Service Bulletin

DATE December 2, 1974

NUMBER 2935-40001

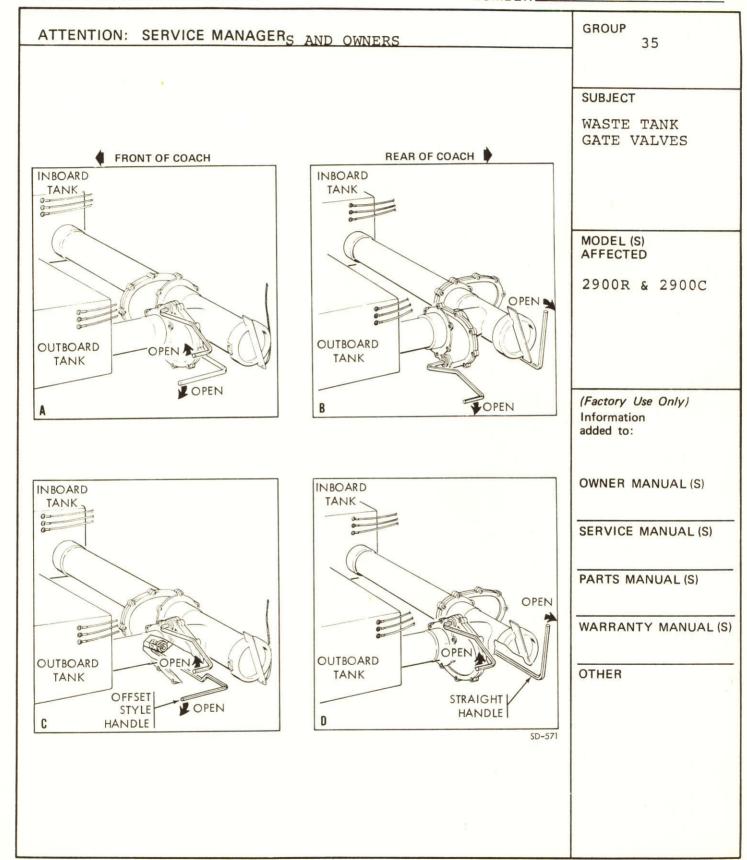
shower drain for inboard tank. Operate the valve handle to determine OPEN and CLOSE for each tank. At same time read the indicator on the domestic panel (leave some water in one tank) to determine if holding tank "1" (inboard) or "2" (outboard) is being read.	OWNER MANUAL (S) SERVICE MANUAL (S)
On some coaches the wiring connections at the domestic panel were reversed. This will not affect the operation of your coach, but you should know which tank you are reading when you press the "hold-	PARTS MANUAL (S) WARRANTY MANUAL (S)
ing tank No. 1" or "holding tank No. 2" switch on the domestic panel.	
The handle to the inboard tank was changed during production, and your coach could have either an offset type of handle (view C used to approximately coach 00299) or a straight type of handle (view D used from approximately 00300 up). The offset type "hooked in" behind the valve, while the straight	OTHER

ATTENTION: SERVICE MANAGERS AND OWNERS	GROUP 35
handle fits directly into the front of the valve. MARKING After you have determined the correct handle position for your coach, and which tank is No. 1 and which is No. 2 at the domestic panel, we suggest you mark these for your future use.	SUBJECT WASTE TANK GATE VALVES
	MODEL (S) AFFECTED
Mux L Snarely MAX SNAVELY Service Manager	2900R & 2900C
	(Factory Use Only) Information added to:
	OWNER MANUAL (S)
	SERVICE MANUAL (S)
	PARTS MANUAL (S)
	WARRANTY MANUAL (S)
	OTHER
